# Mobile Intel<sup>®</sup> Pentium<sup>®</sup> II Processor Specification Update

Release Date: June 2002

Order Number: 243887-041

The Mobile Pentium<sup>®</sup> II processor may contain design defects or errors known as errata which may cause the product to deviate from published specifications. Current characterized errata are documented in this Specification Update.

New Mobile Pentium® II Processor in Mini-Cartridge Package Label with Supplier Matrix Mark Removed

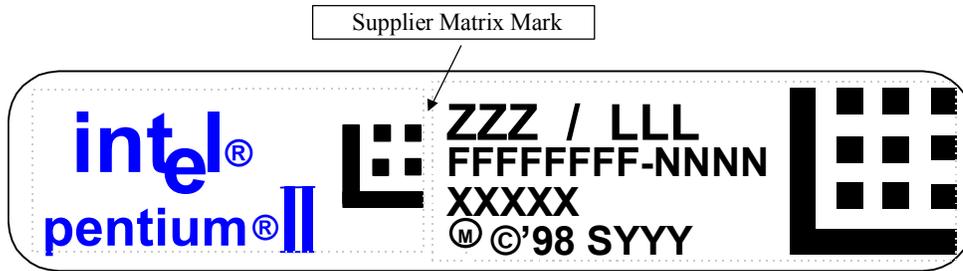
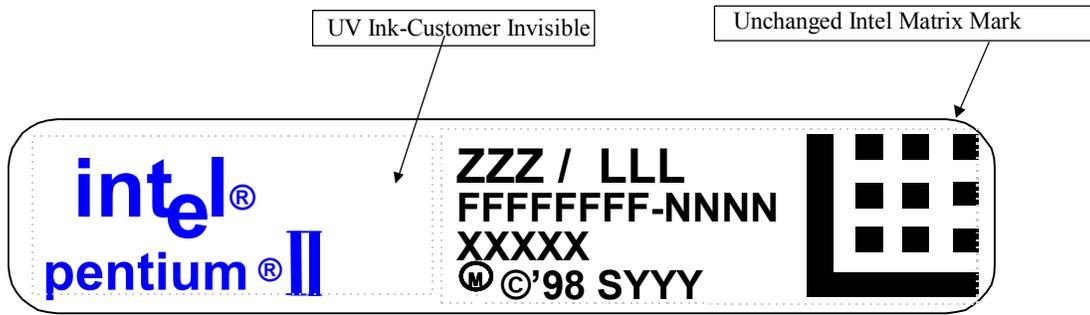
Old Mobile Pentium® II Processor in Mini-Cartridge Package Label with Supplier Matrix Mark

**Figure 1. An Example of Microcontroller Driven Thermal Management**

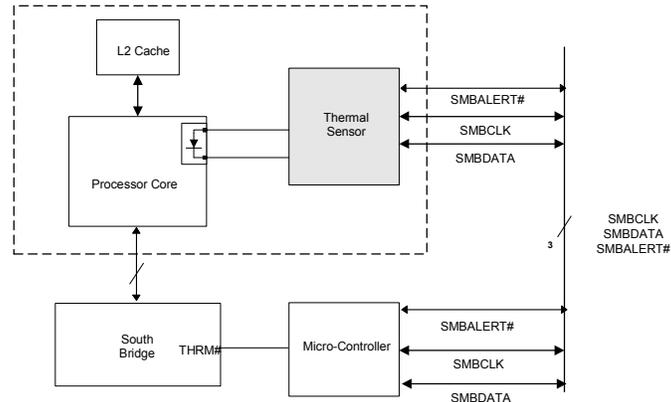
**Problem:** The Mobile Pentium II processor and the Pentium II Processor Mobile Module have a thermal sensor that monitors the processor core's temperature. Please note that desktop systems could have a similar thermal device. The thermal sensor asserts SMBALERT# if the processor temperature exceeds the temperature limits set in the Alarm Threshold Registers ( $T_{HIGH}$ ,  $T_{LOW}$ ). It also sets the corresponding Status Register bits to identify the cause of the interrupt. Figure 1 gives one example of the how the SMBALERT# signal could be used in a system.

Figure 2. Workaround Flowchart: SMBALERT#-Driven System

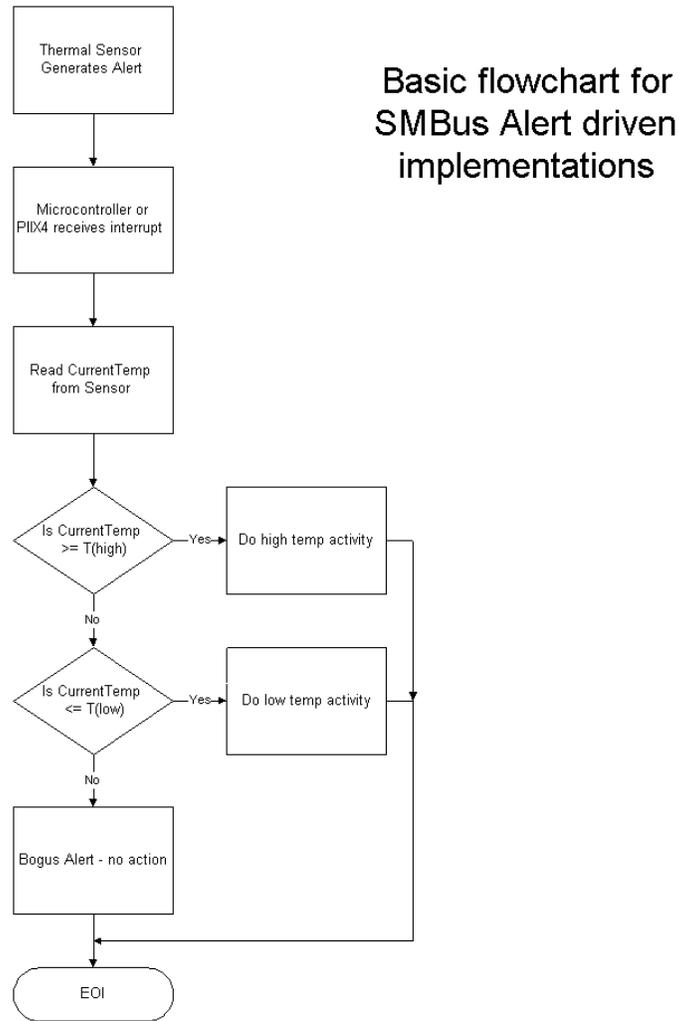
1. Before servicing an interrupt from the thermal sensor, read and compare the processor thermal reading with the threshold limits ( $T_{HIGH}$  or  $T_{LOW}$ ). Figures 2 and 3 provide basic flowcharts for the implementation of this workaround in an interrupt driven system.
2. If the firmware implemented polls the Status Register only, then before taking any action, re-read the temperature register and do a comparison with the alarm threshold limits ( $T_{HIGH}$  or  $T_{LOW}$ ) to determine if the value is actually still within the temperature window.

**Figure 3. Workaround Flowchart: SMI#-Driven System**

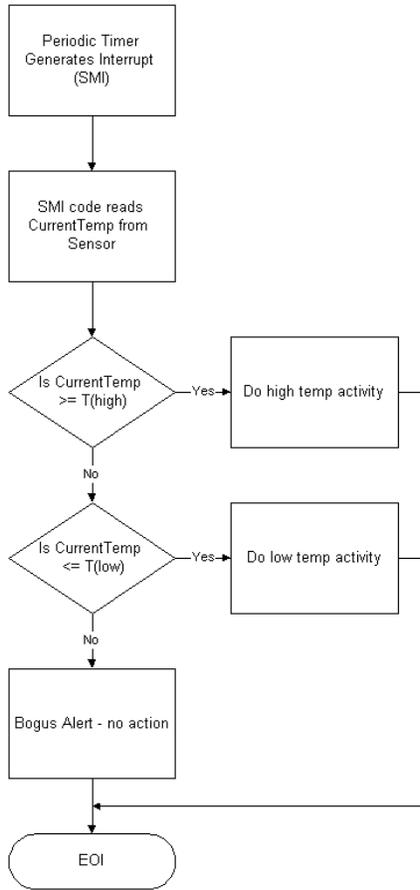
- Use a temperature polling scheme to monitor the processor temperature.

**Figure 1. TAP Gageable Thread Clarification**

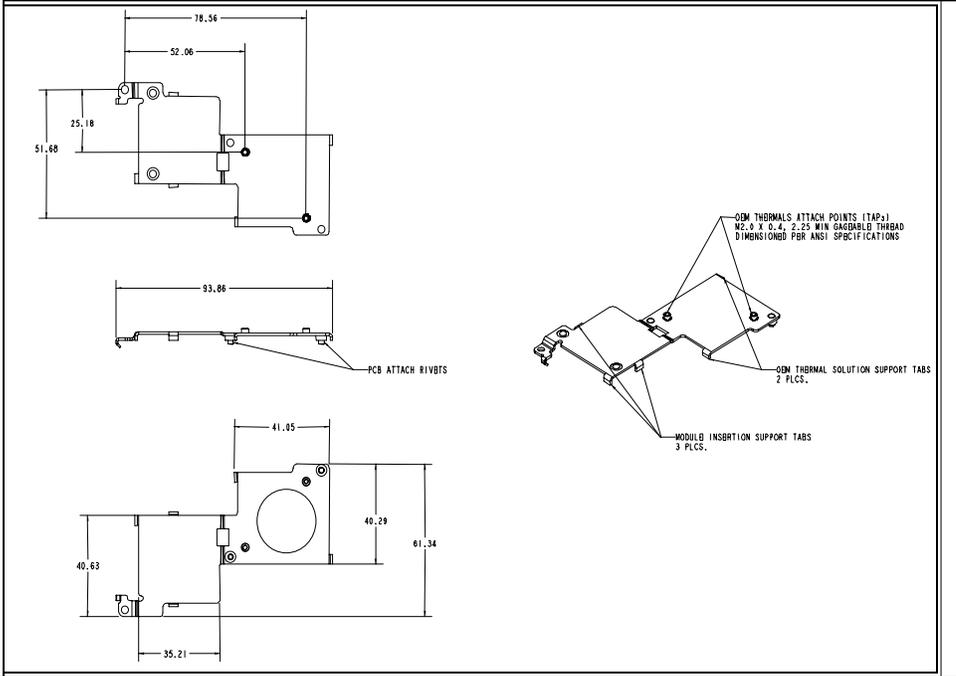
In the *Intel® Pentium® II Processor Mobile Module : Mobile Module Connector 1 (MMC-1)* and the *Intel® Pentium® II Processor Mobile Module : Mobile Module Connector 2 (MMC-2)* datasheets (Order Numbers 243667 and 243668, respectively), the thermal attach point (TAP) gageable thread specification was not clearly identified in Figure 14, of Section 5.2. The following is the TAP clarification:

OEM Thermal Attach Points (TAPs) M2.0 x 0.4, 2.25 min gageable thread dimensioned per ANSI specification.
